ADDENDUM NUMBER 8

- 1.01 DATE: APRIL 13, 2021
- 1.02 PROJECT: WELCOME CENTER
- 1.03 PROJECT NUMBER: DCM NO. 2020604
- 1.04 OWNER: ALABAMA A&M UNIVERSITY
- 1.05 ARCHITECT: NOLA | VAN PEURSEM ARCHITECTS, PC

SHEET NUMBER
A-7.4
OF

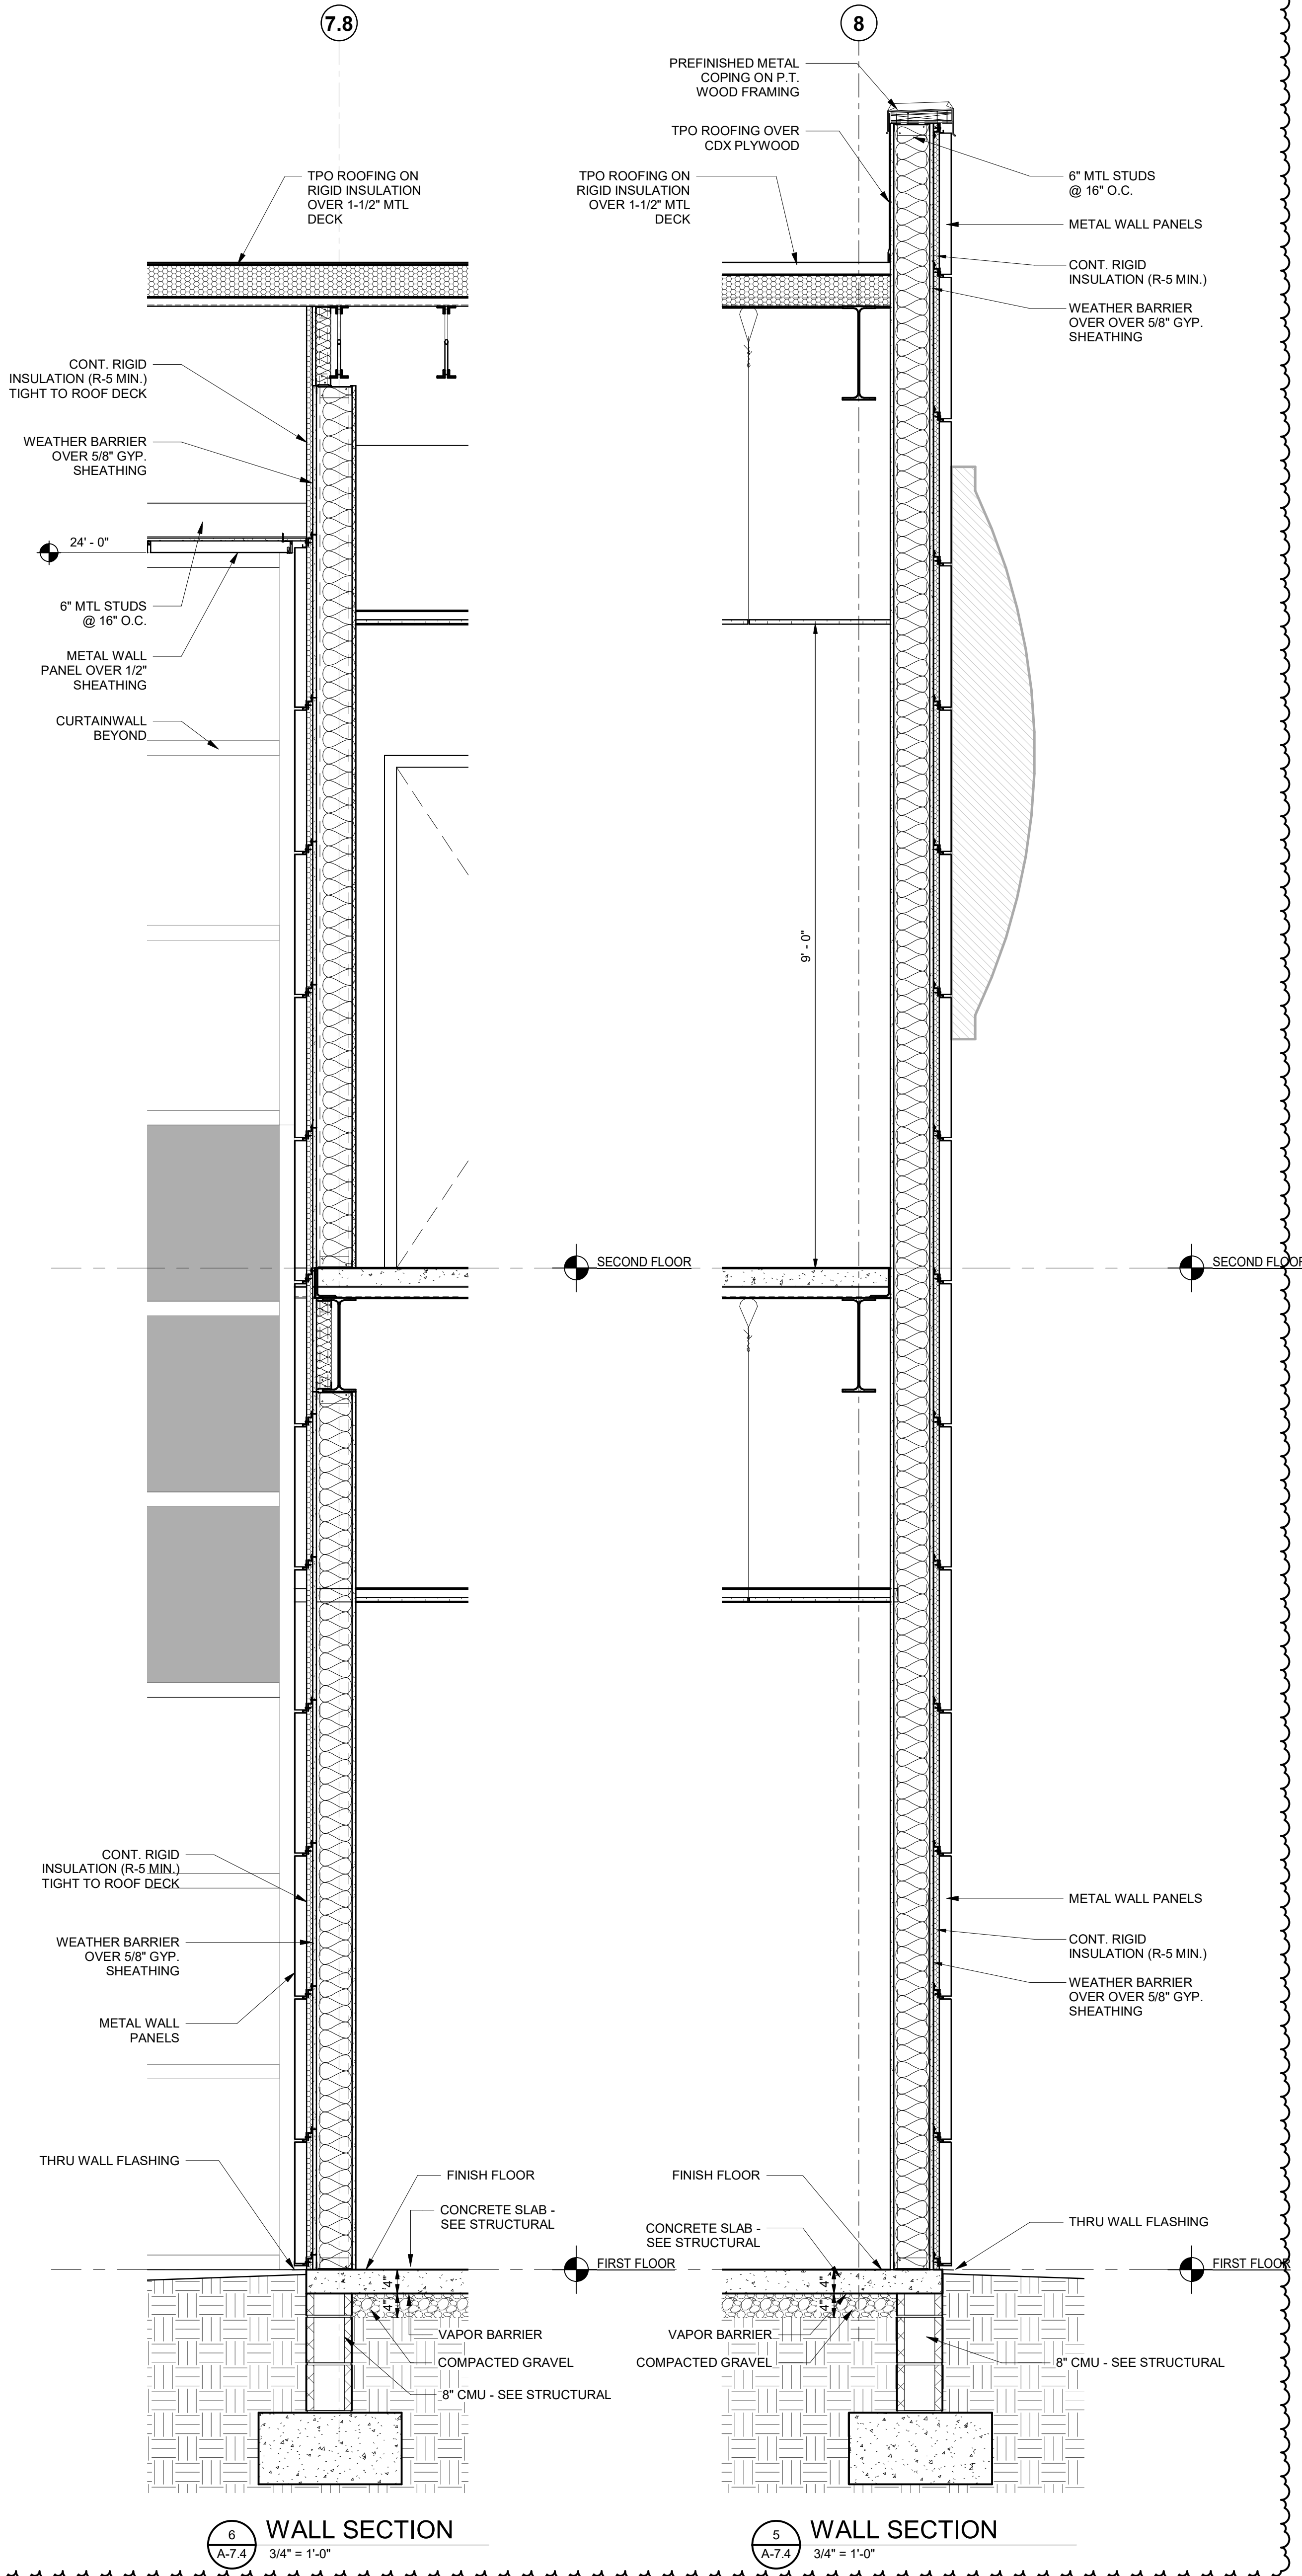
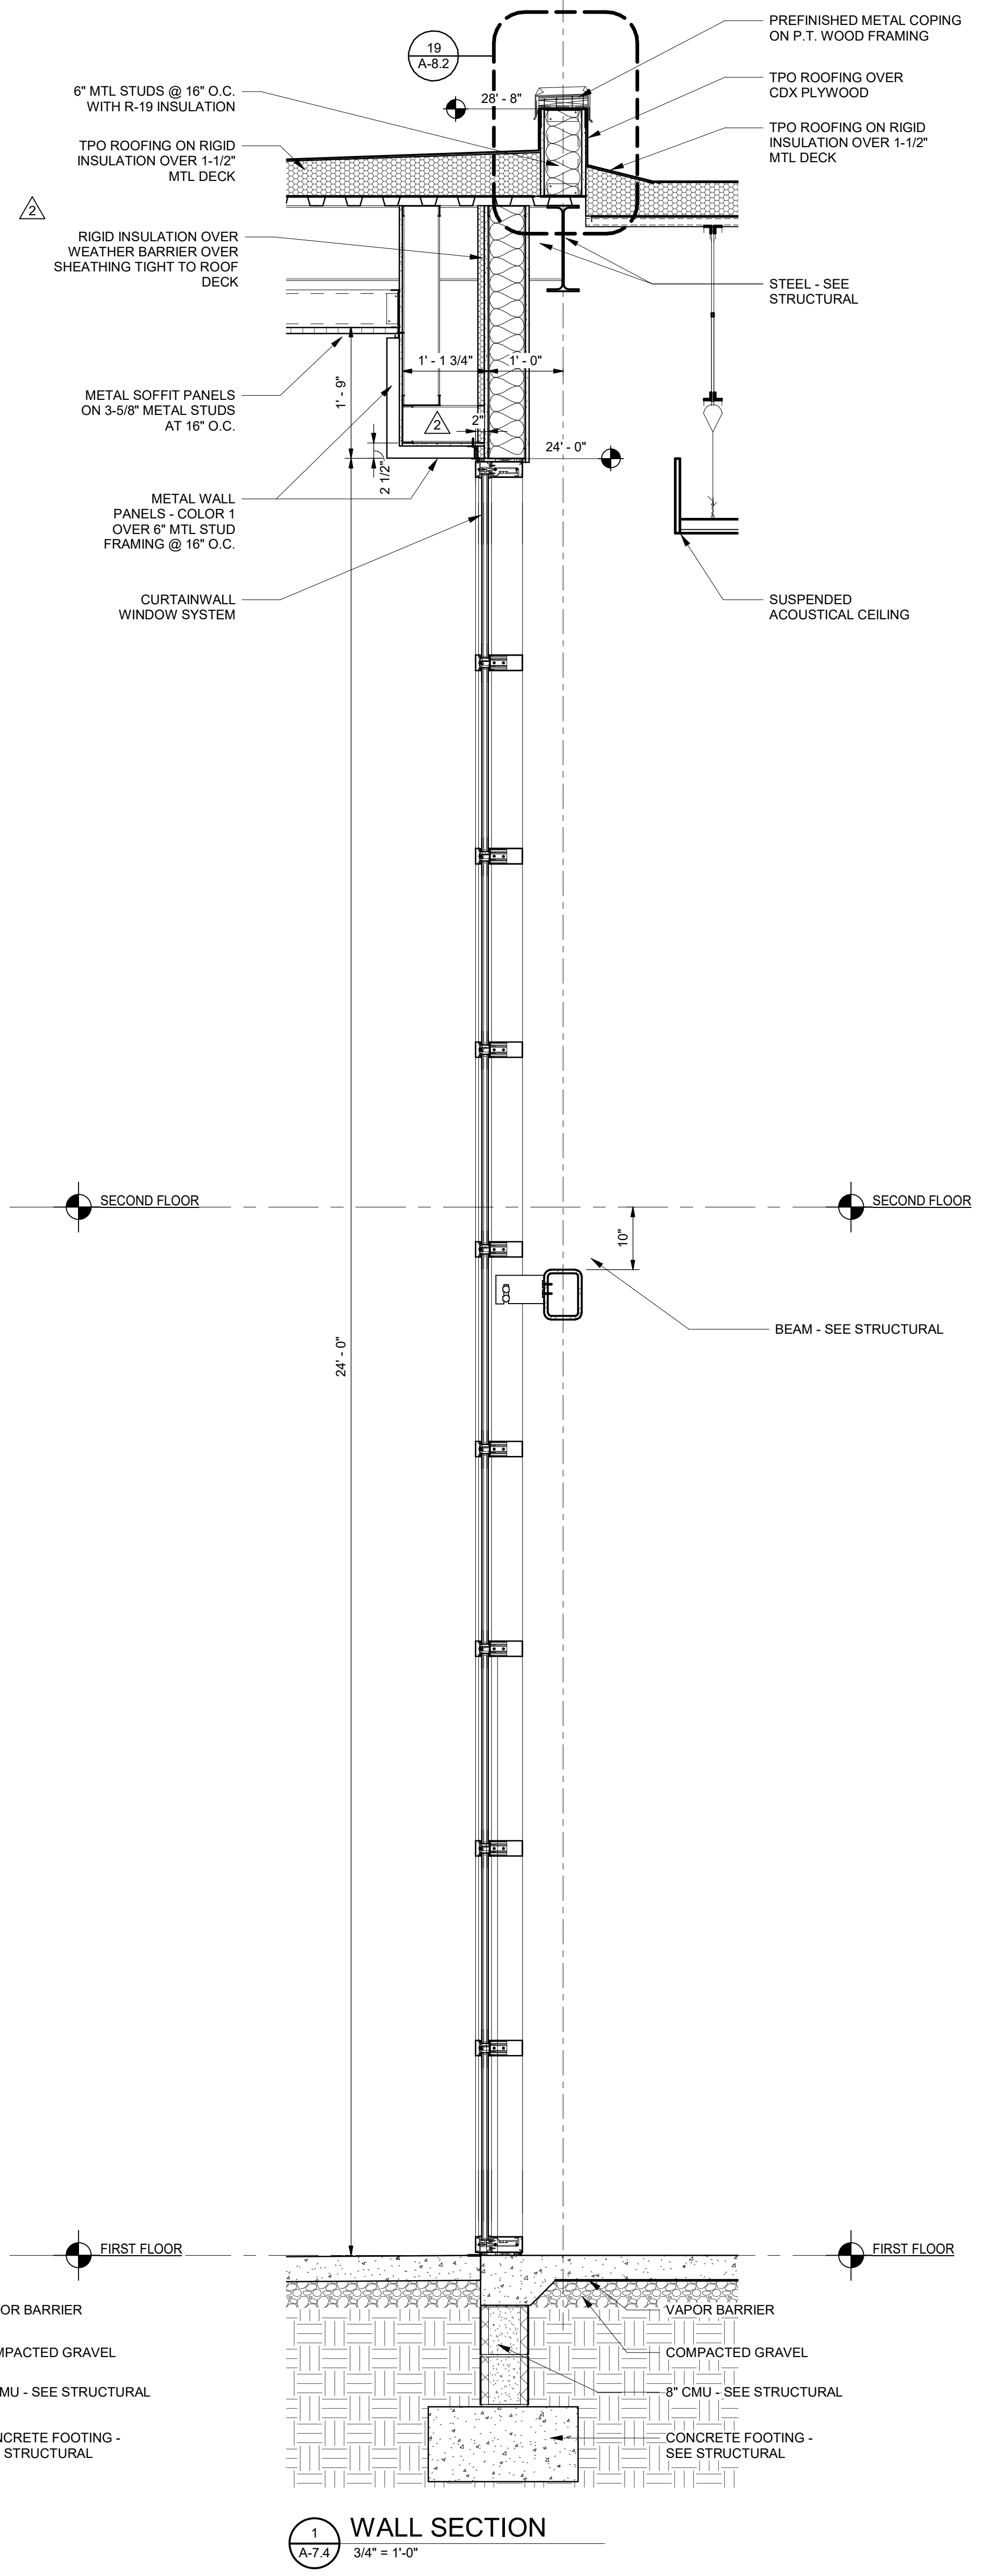
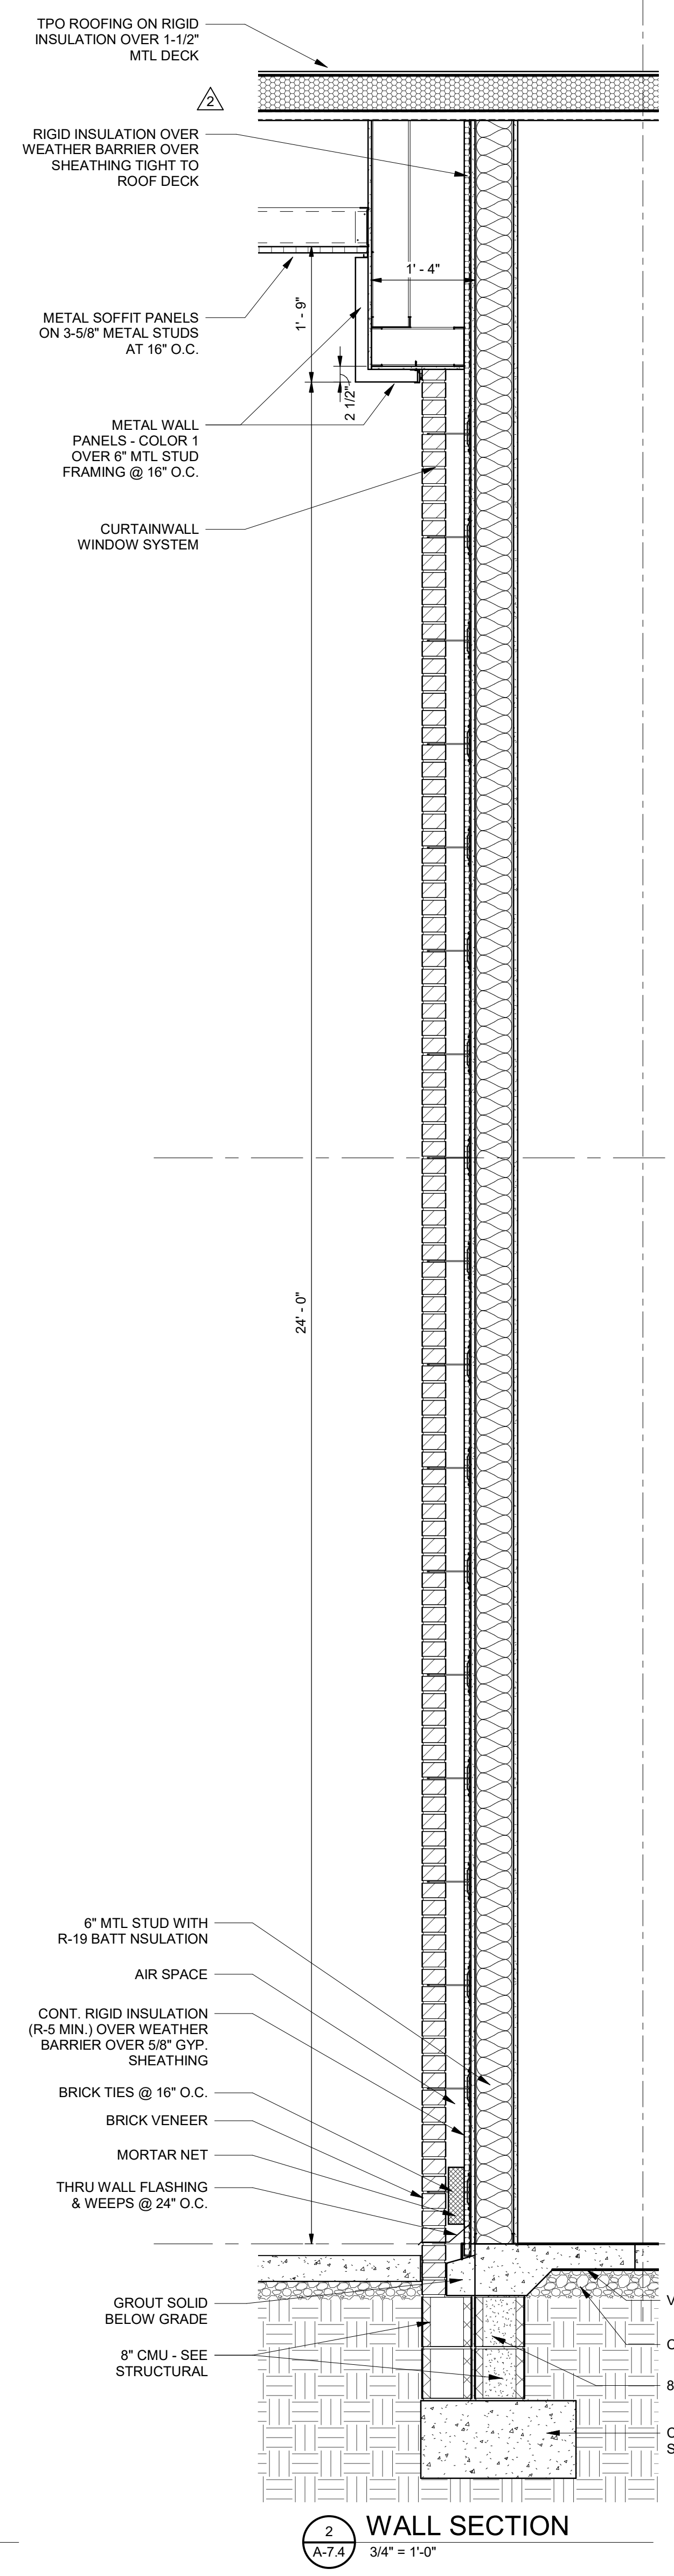
4.04 SHEET A-7.4 – WALL SECTIONS:

A. Replace this sheet in its entirety. Revisions include: two added wall sections.
